**SITE PLAN REVIEW SHEET  
ENVIRONMENTAL VARIANCE REQUEST ONLY**

**CASE:** SP-2020-0228D

**PROJECT NAME:** Brushy Creek Regional Utility Authority Raw Water Pump Station

## **ENVIRONMENTAL COMMISSION MOTION 20201202 002a**

REV.	DESCRIPTION	DATE
RAW WATER PUMP STATION		
SLOPE MAP		
9-4-2020 <i>David P. Smith</i> DATE DAVID P. SMITH		
	PM	ADA
	DESIGNED	DPS
	DRAFTED	TFG
	CHECKED	DPS
	PROJECT NO.	3-00670.01
DRAWING NO. <b>CD-5</b>		
SHEET 6 OF 35		
SP-2020-0228D

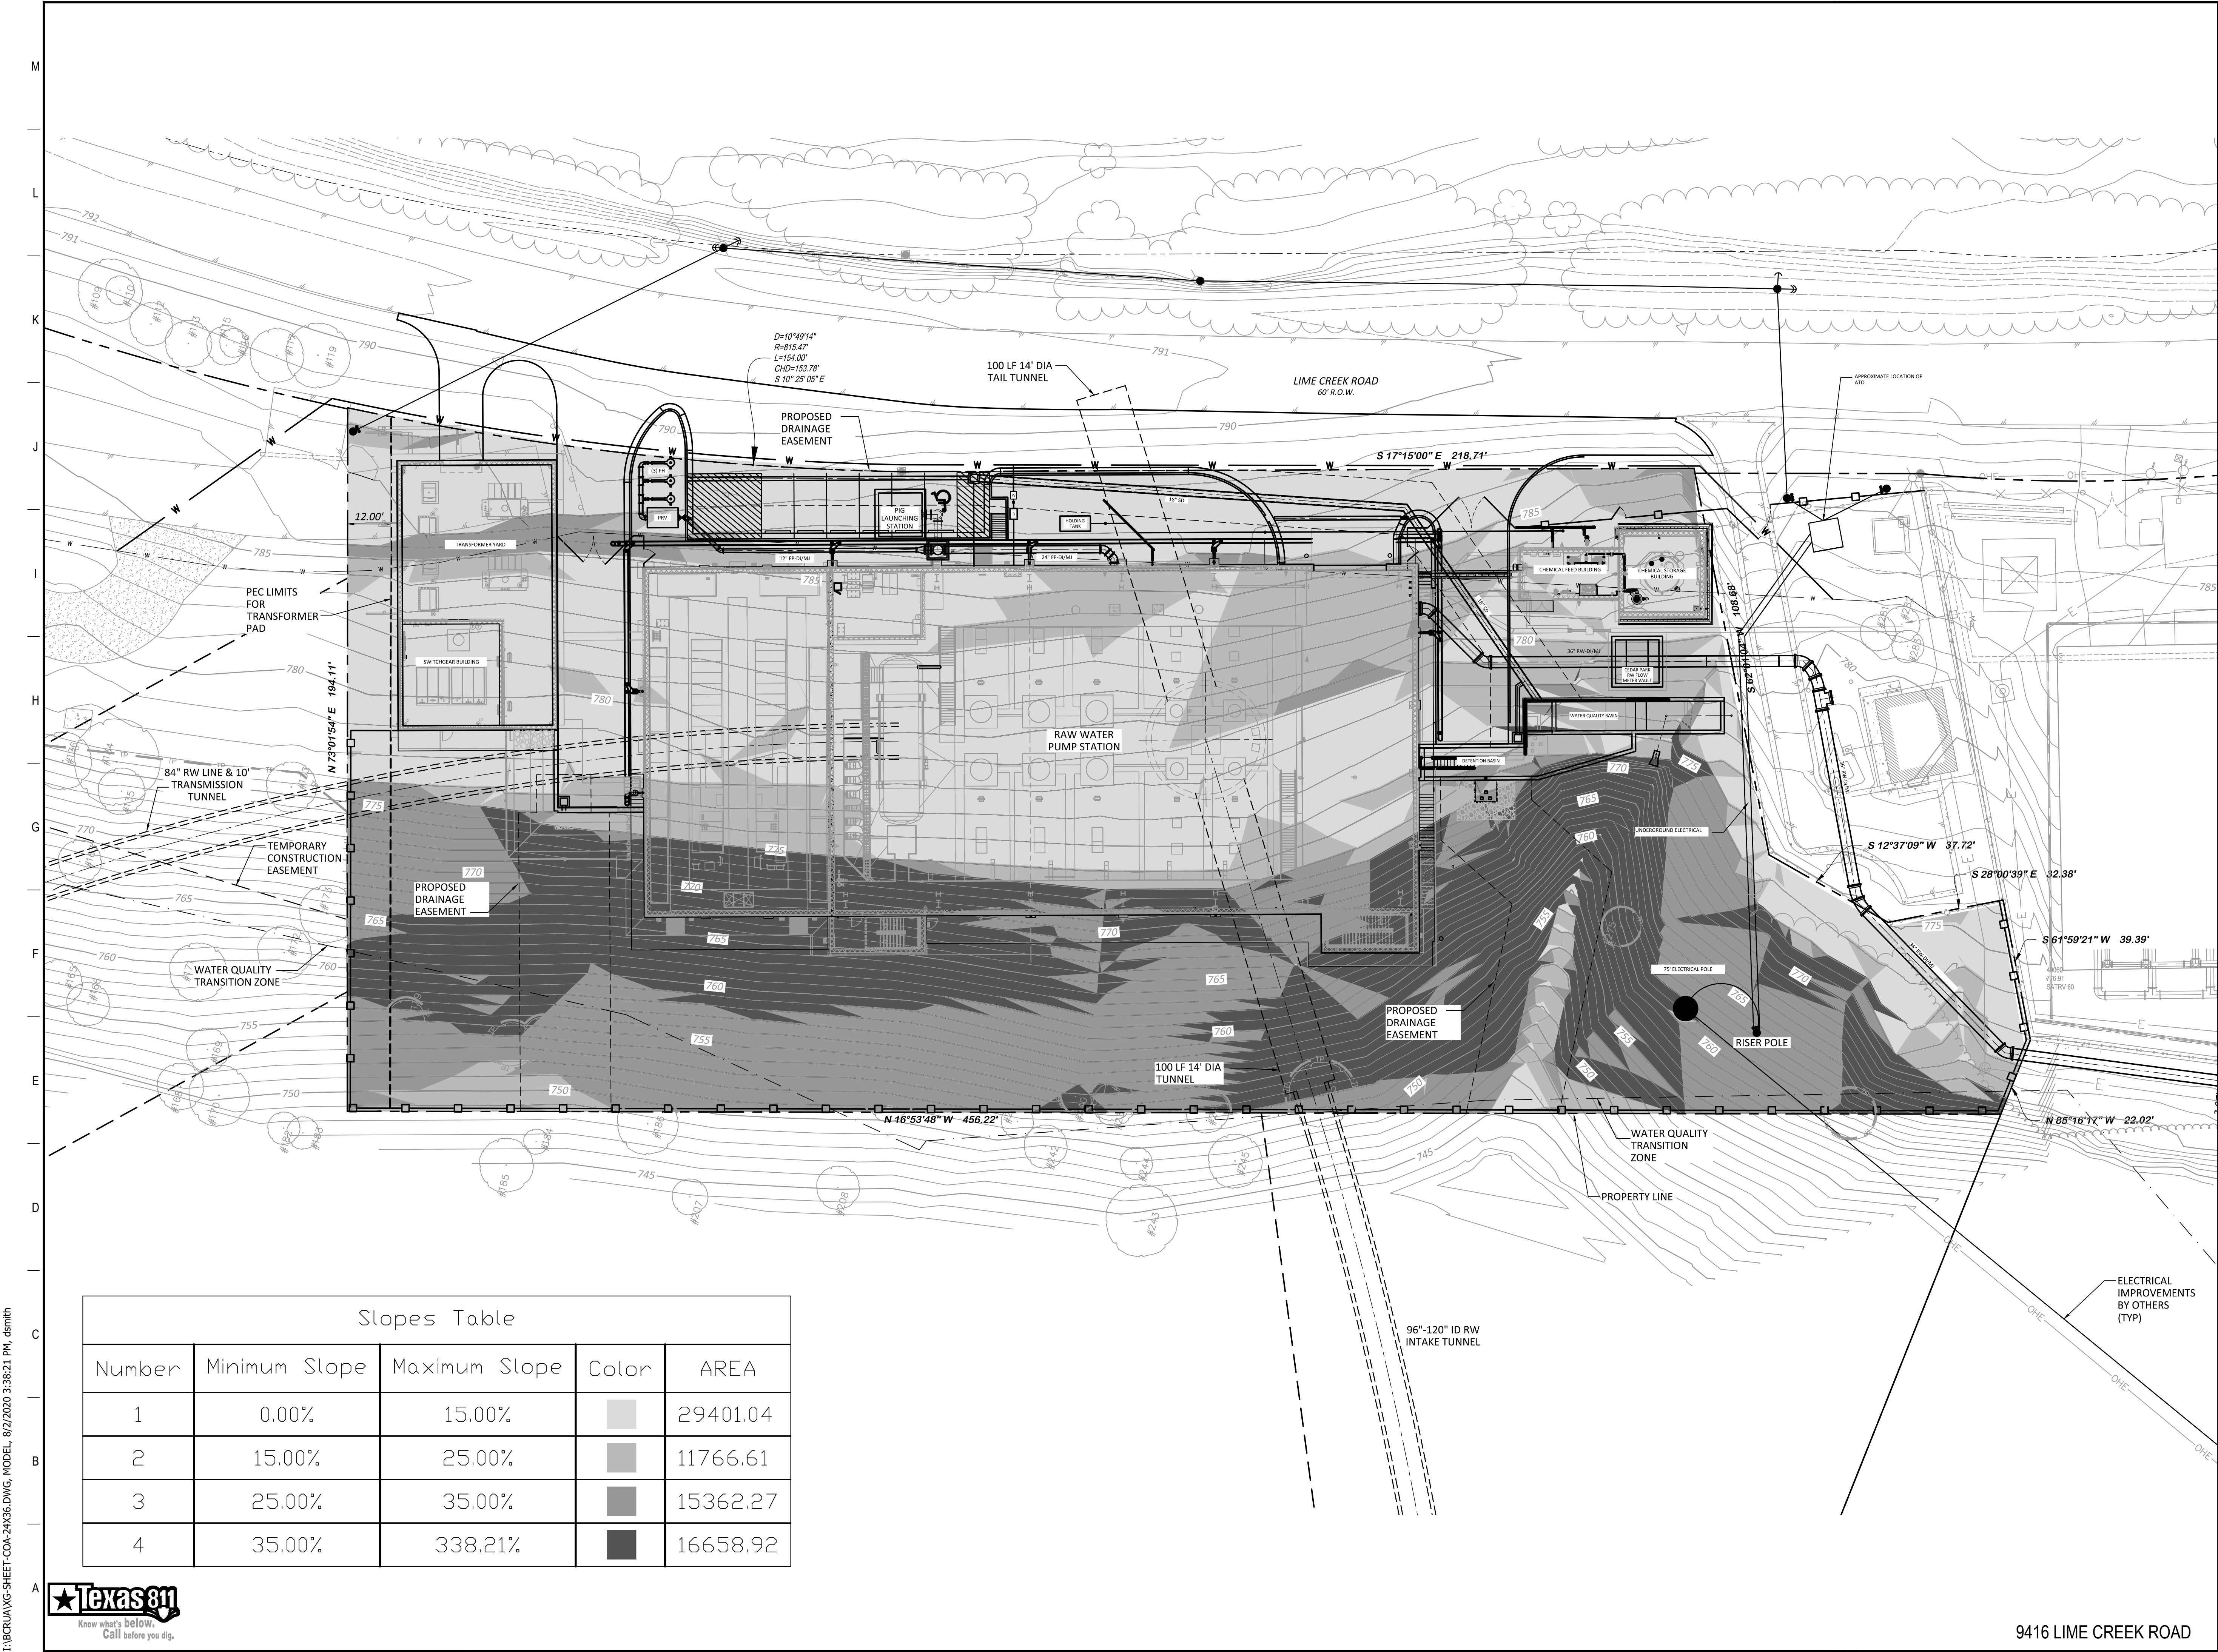
maximum allowed gradient set by Travis County fire regulations (see Fill Exhibit, page 35). The surface parking lot and the building are sited on the least sloped areas of the site, and only propose the amount of square footage necessary for the functioning of the facility to meet the projected water demands and provide safe accommodations for the employees (see Slope Exhibit, page 36).

I:\BCRIA\RESTORATION.DWG, RESTORATION EXHIBIT, 9/29/2020 9:56:02 AM, dsmith

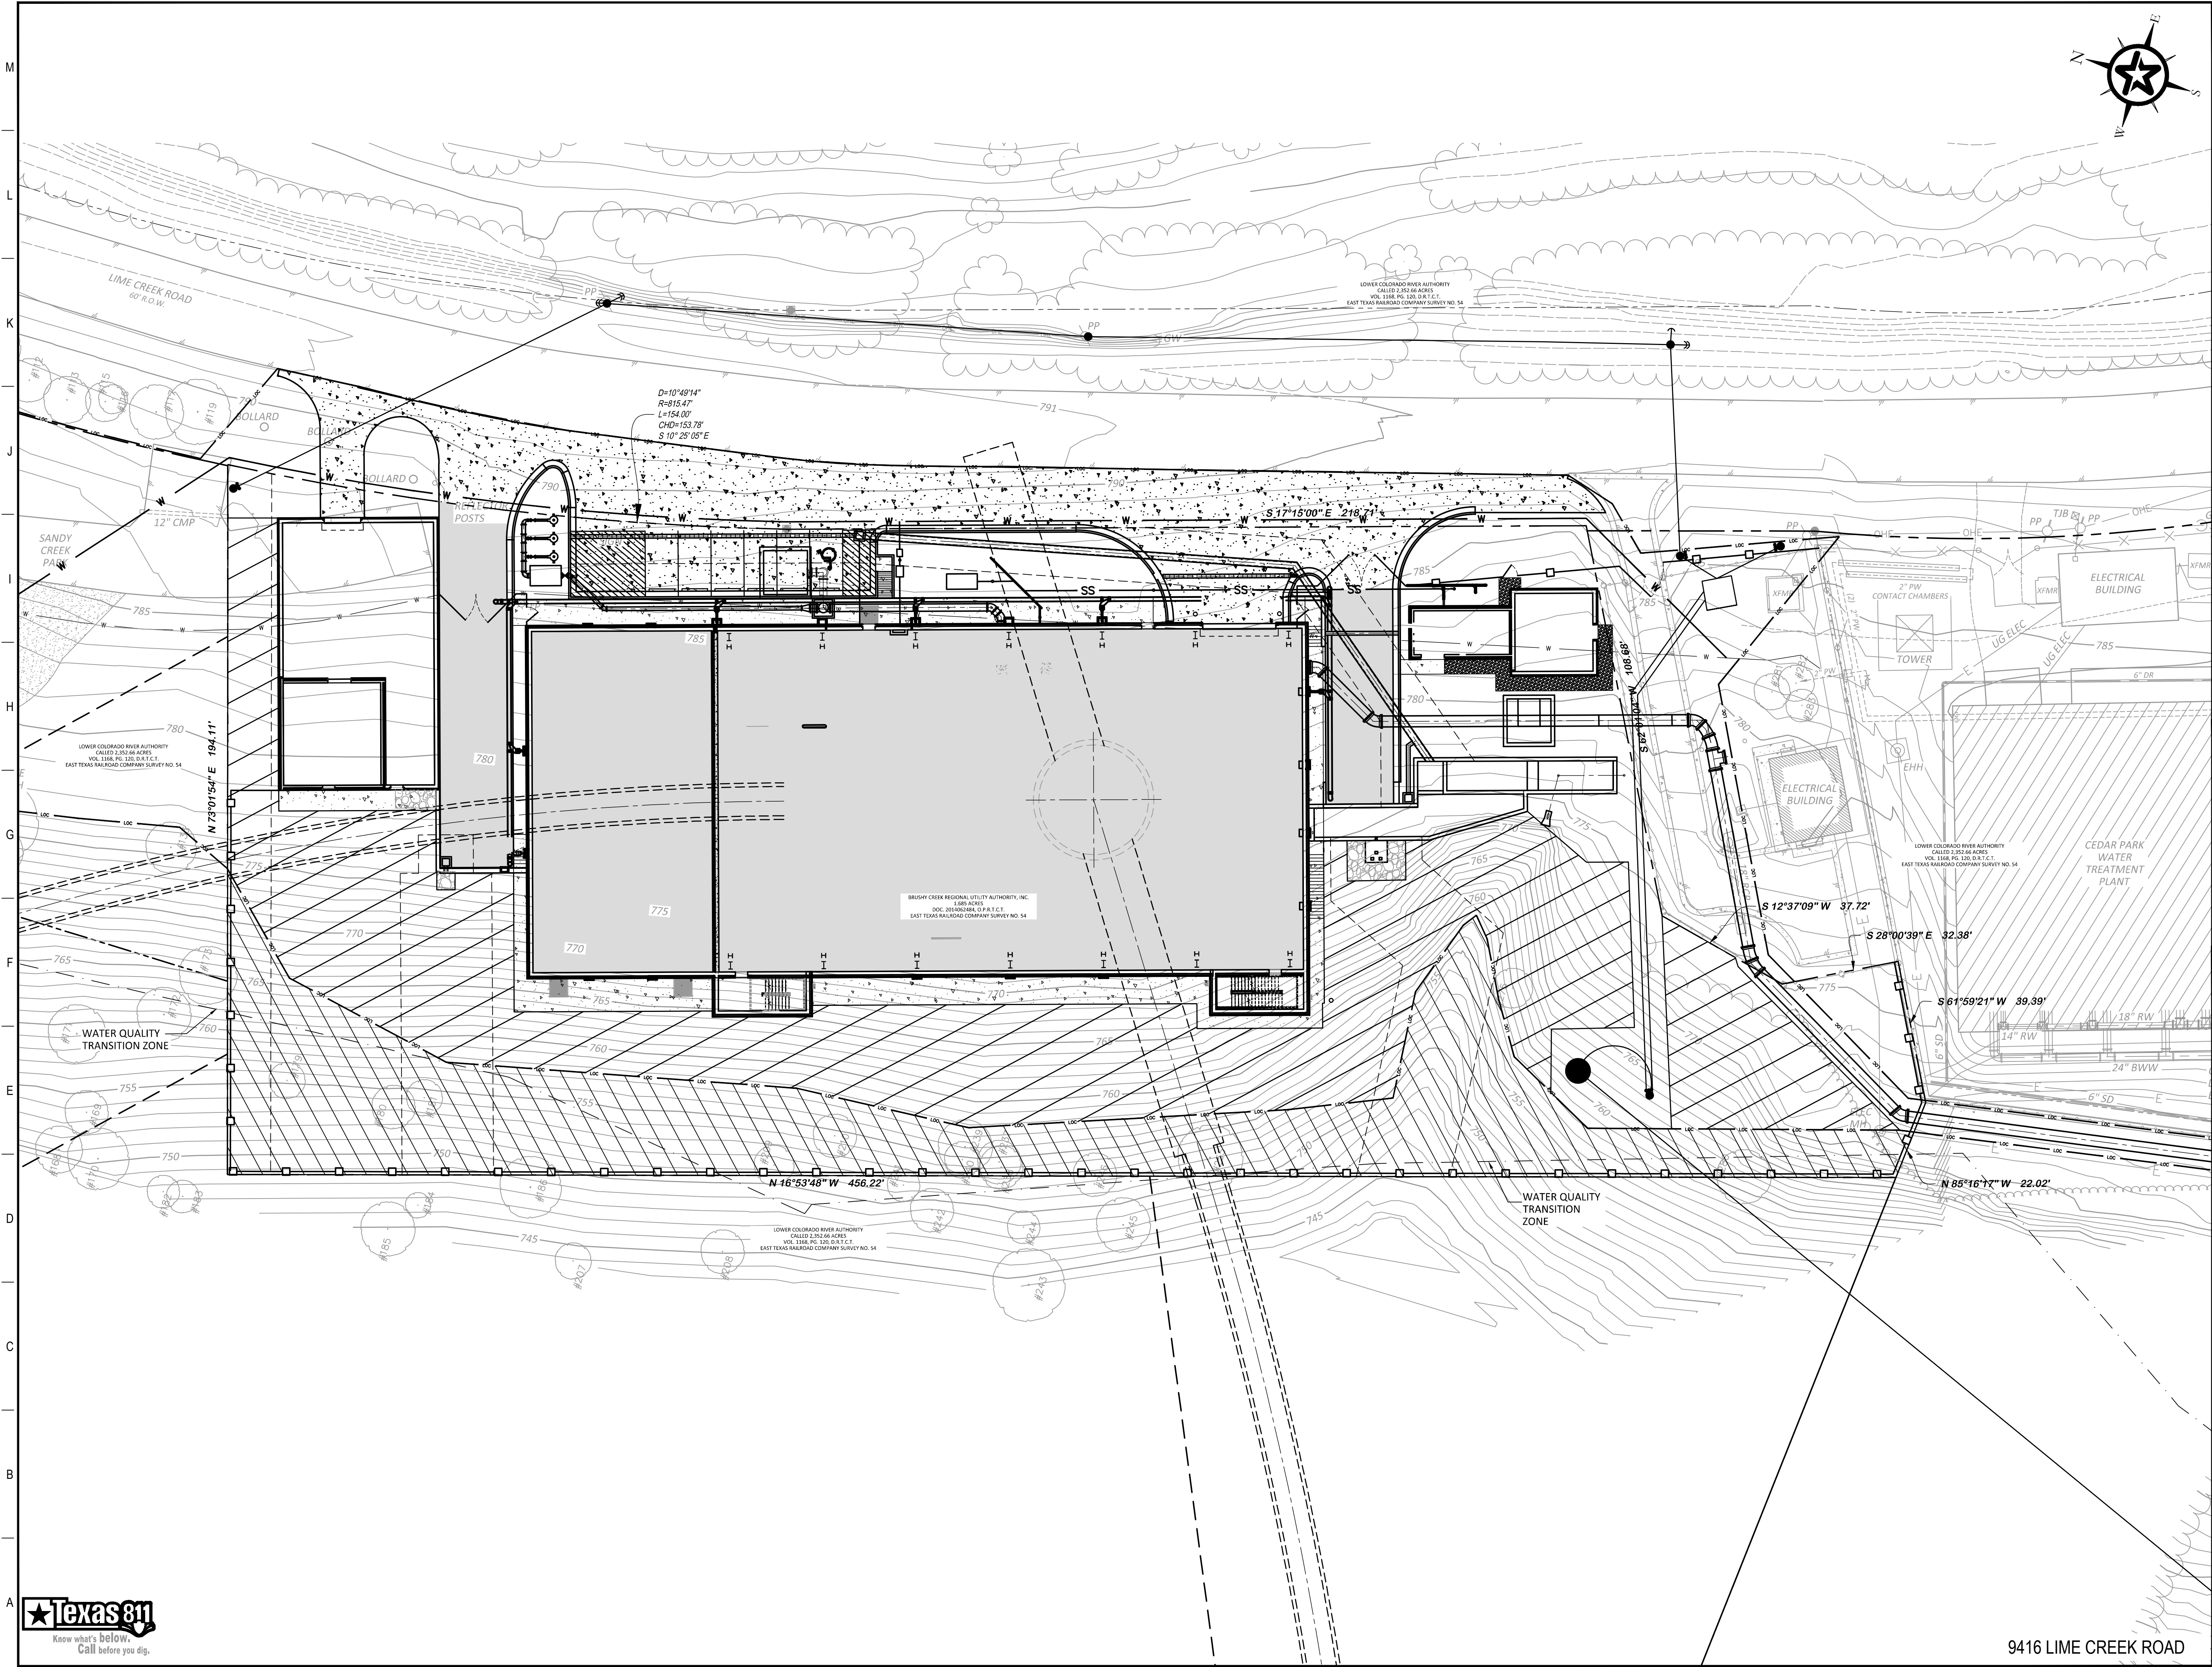
buffer preserves and/or restores natural vegetation, soils, and topography to serve receive overland drainage from the developed areas for water quality benefits, and provides a natural vegetative buffer and setting for the developed area to fit more naturally into the landscape and be screened from lake users (see Restoration Exhibit, page 37).

1. Restoration of disturbed areas within the 40% Natural Area Buffer shall be subject to ECM Appendix A criteria
2. Provide robust temporary and permanent erosion and sedimentation controls downgradient of the proposed development beyond the minimum standard
3. Provide dense screening vegetation in compliance with ECM 2.9.0 for all pervious areas between the building and mechanical equipment and the right-of-way.
